BOARD ACTION REPORT – APPEALABLE ITEM

Project Name: 131 NE 1st Avenue
Project Location: 131 NE 1st Avenue, Old School Square Historic District
Request: Certificate of Appropriateness
Board: Historic Preservation Board
Meeting Date: March 7, 2018

STAFF REPORT

ITEM: 131 NE 1st Avenue, Old School Square Historic Arts District – Certificate of Appropriateness (2017-301) for the demolition of an existing noncontributing one-story duplex structure, and construction of a new two-story, single-family residence with 2-car garage.

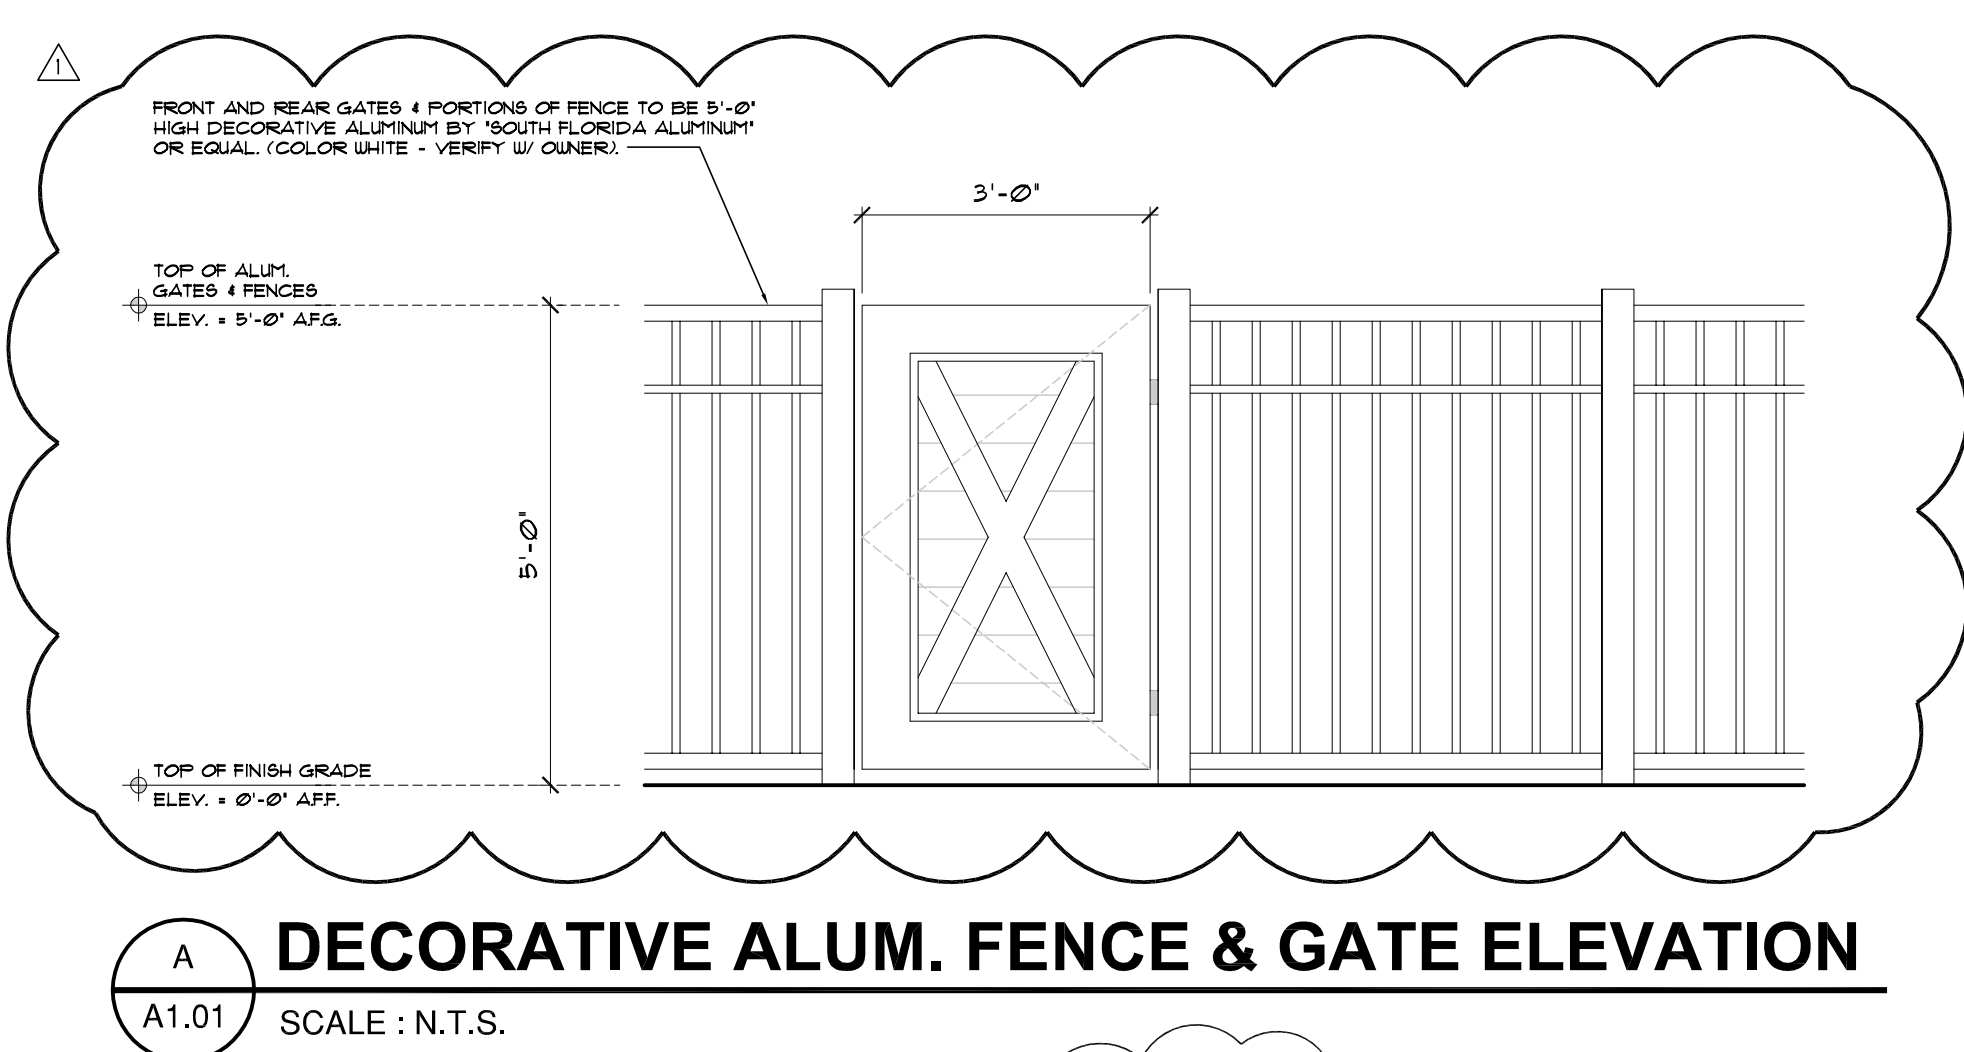
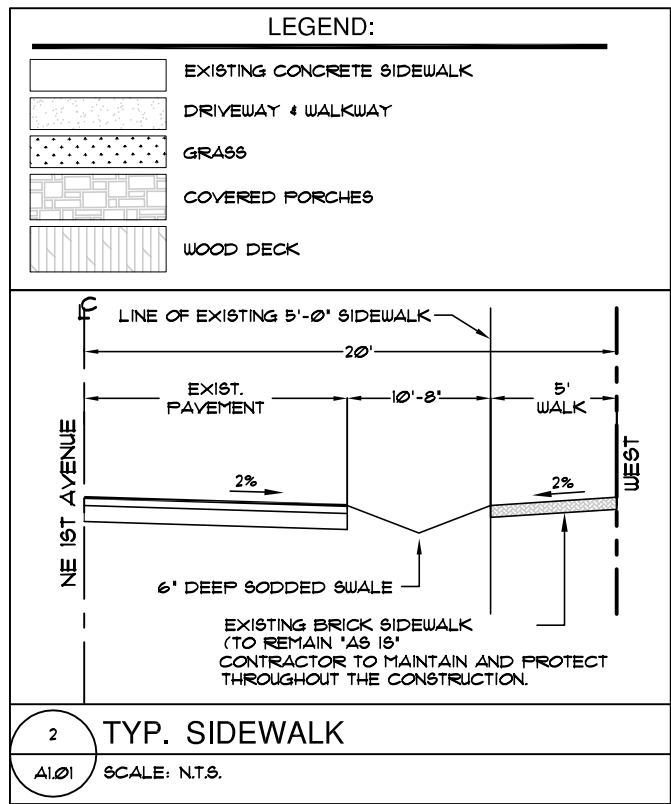
1. That the plans be updated to replace the operable window facing the air conditioner units and generators on the North elevation with a fixed window.
2. That the fencing and gates proposed be illustrated on the site plan.

A1.01

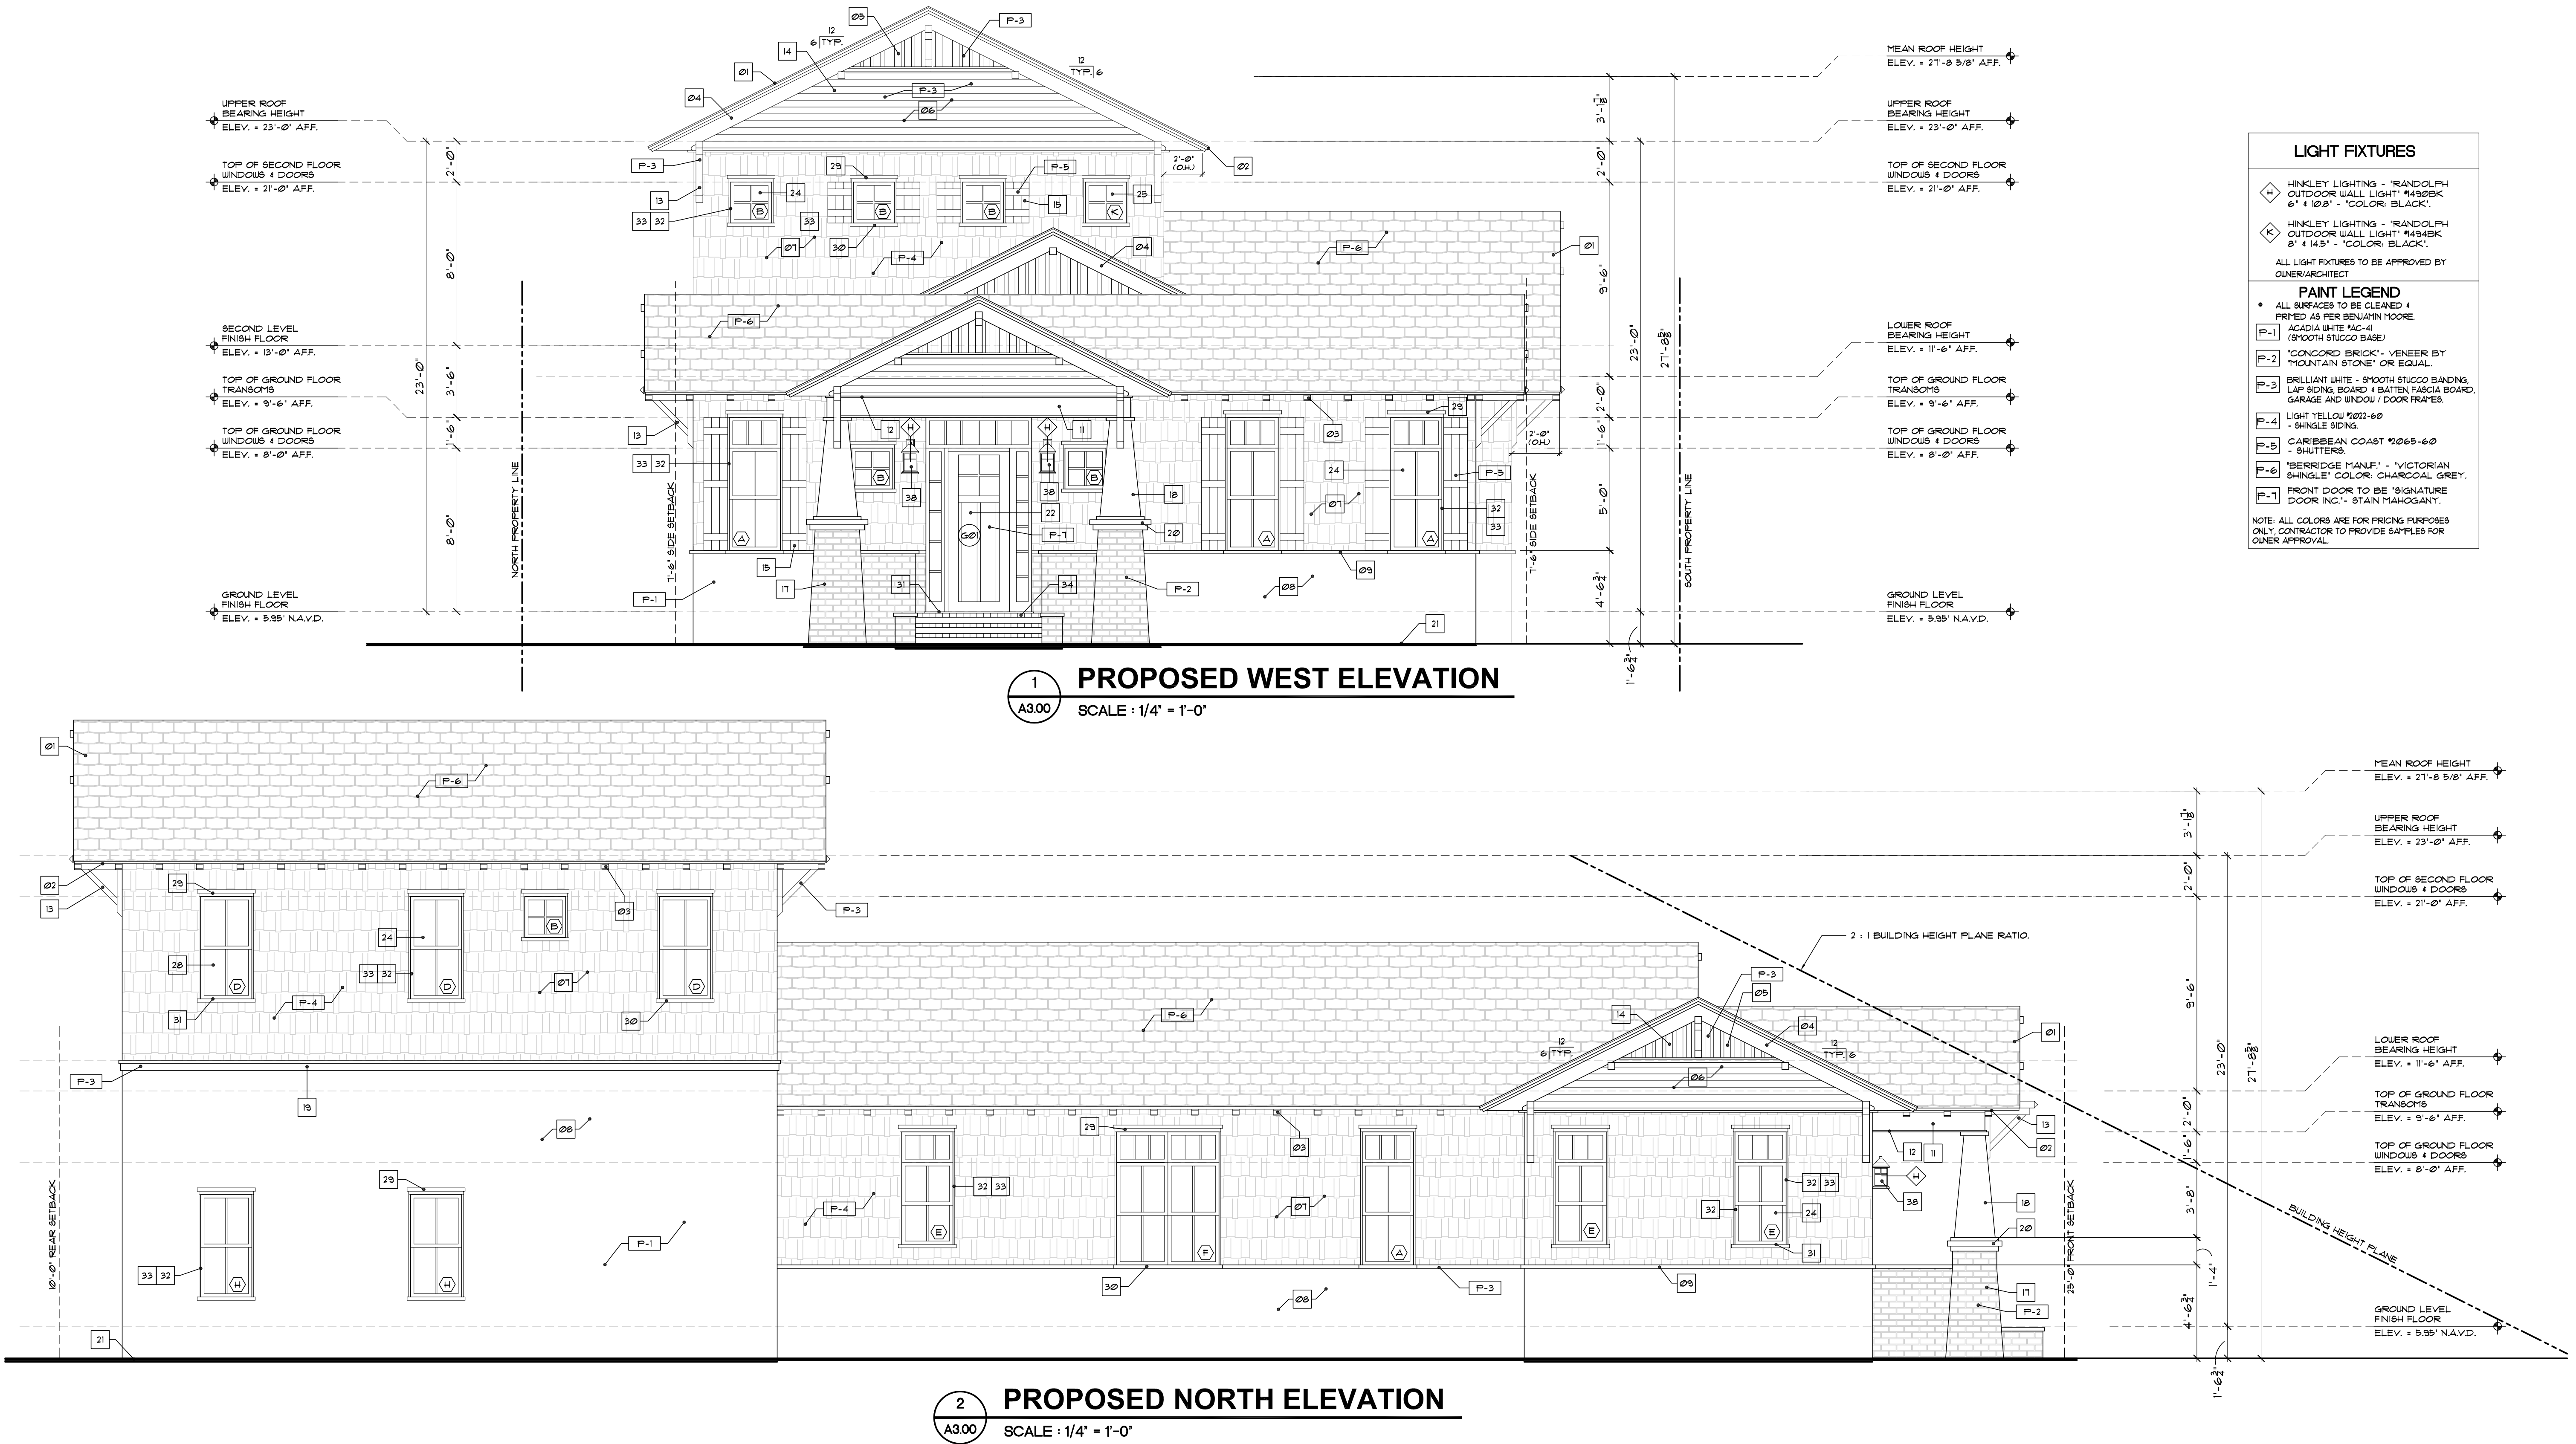
- REVISED 2.8.18 AS PER TAC COMMENTS:
- SPECIFIED LOCATION FOR SOLID WASTE BINS - TO BE HOUSED IN GARAGE SPACE
 - FRONT & REAR GATES & FENCES WILL BE ALUMINUM SIDE FENCES WITH VINYL COATING
 - PROVIDED ELEVATION OF PROPOSED FENCE & GATE
 - REMOVED REFERENCE TO R-1-A ZONING DISTRICT.
 - INCREASED DISTANCE OF A/C UNITS FROM PROPERTY LINE AND PROVIDED DIMENSION.
 - PROVIDED ADJACENT PROPERTY DRIVEWAY LOCATIONS & DIMENSIONS.
 - ADJUSTED FRONT SETBACK 5'-0" EAST TO REFLECT 5'-0" RIGHT-OF-WAY DEDICATION ON WEST SIDE OF PROPERTY.

A3.01

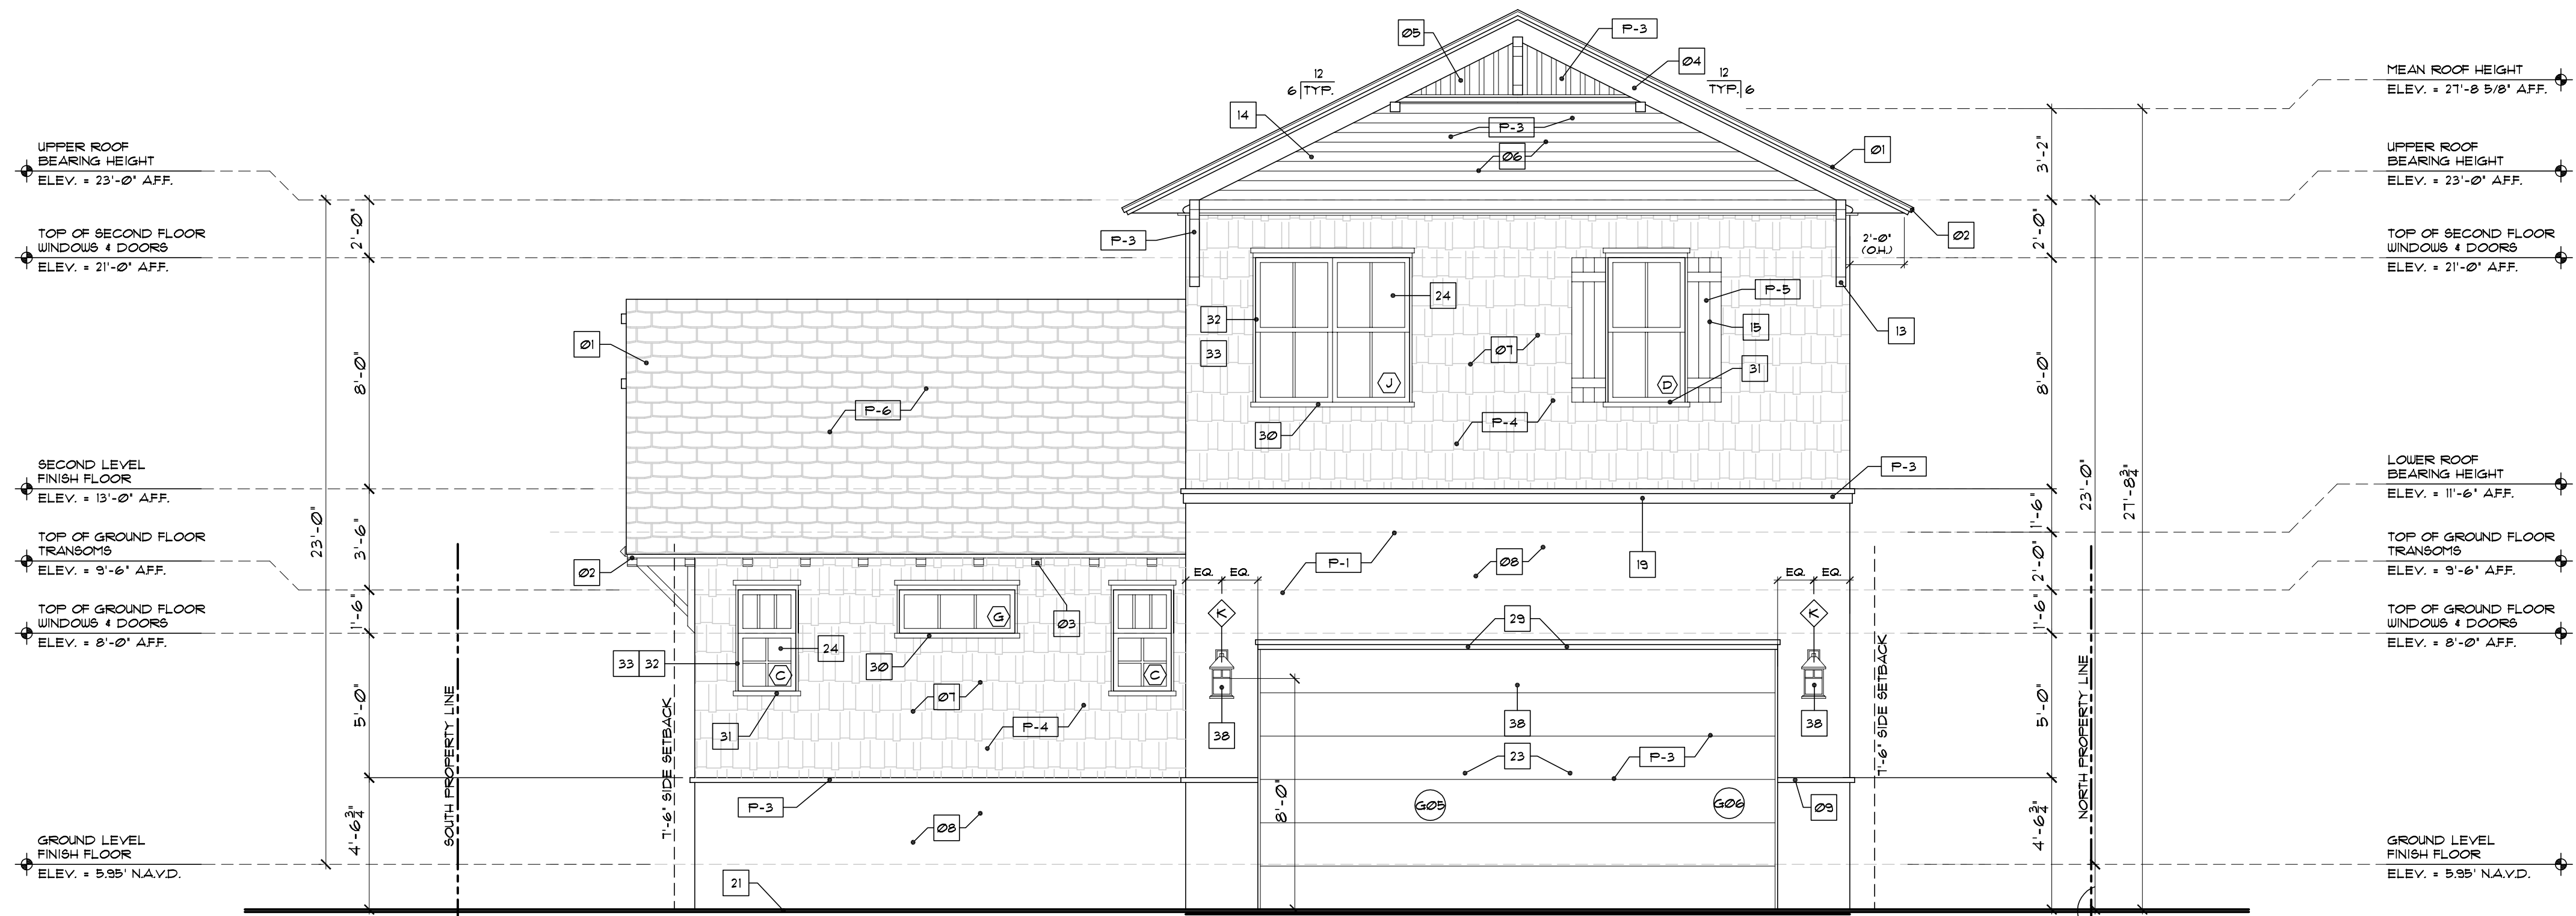
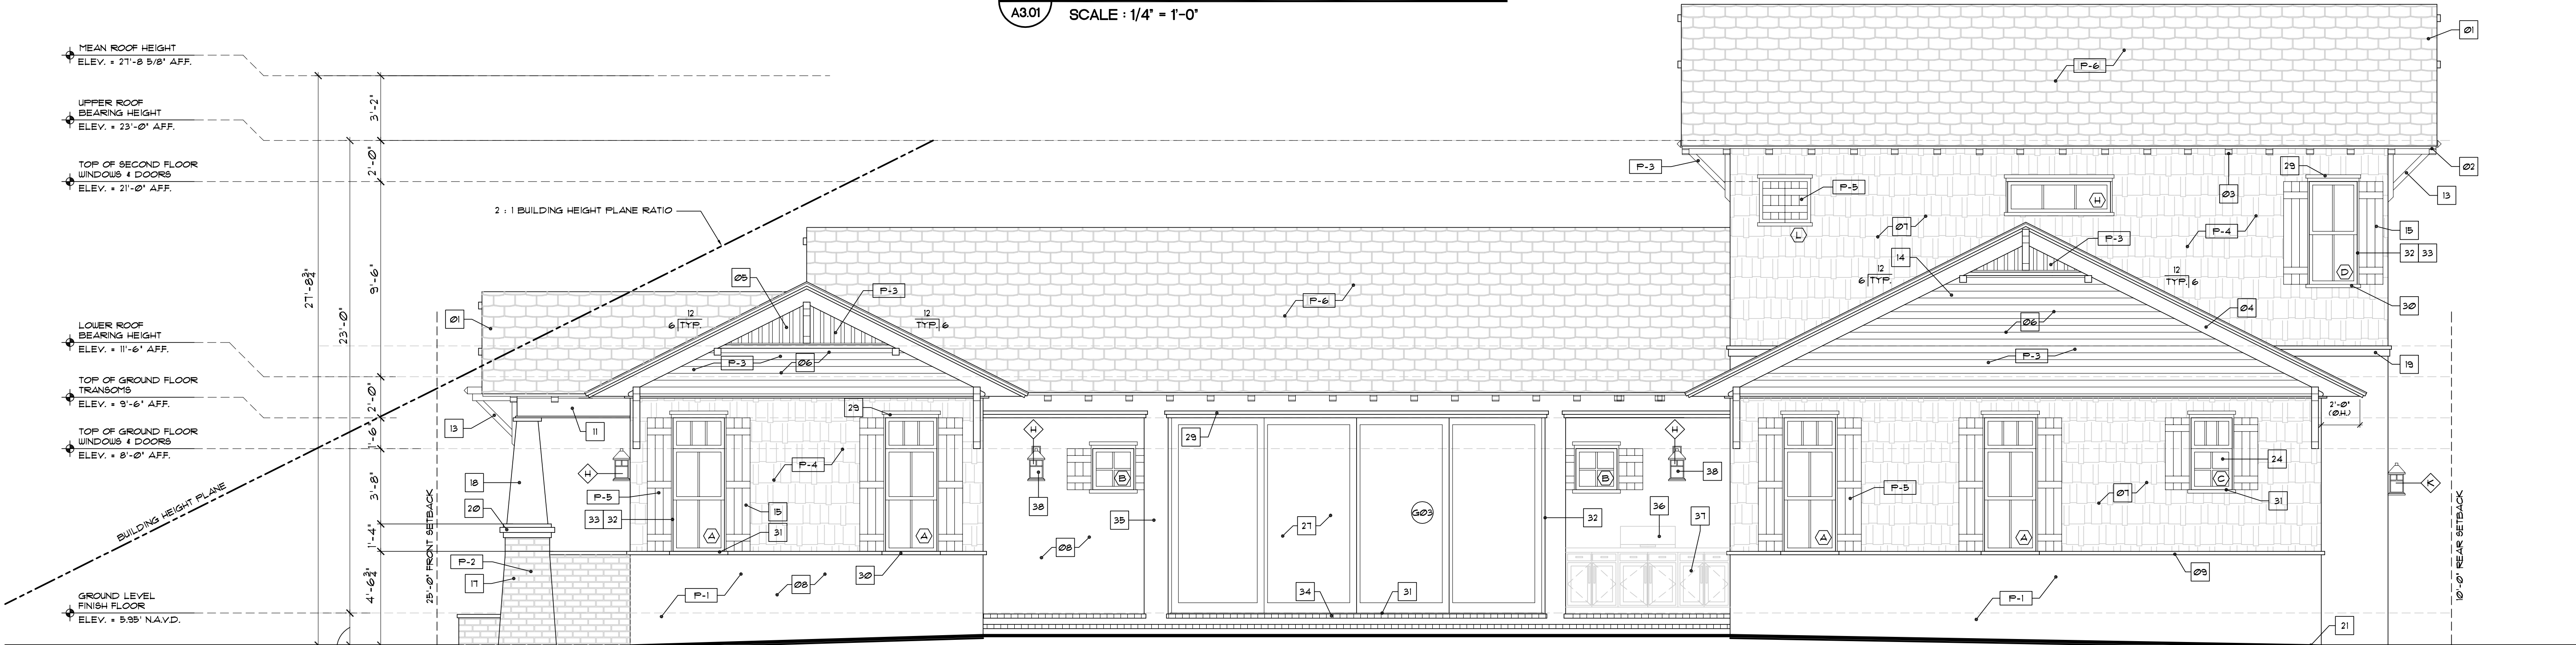
REVISIONS
△ REVISED 2.8.18 AS PER TAC COMMENTS:
ADDED NOTE CLARIFYING GLASS IN WINDOWS AND DOORS WILL NOT BE REFLECTIVE.
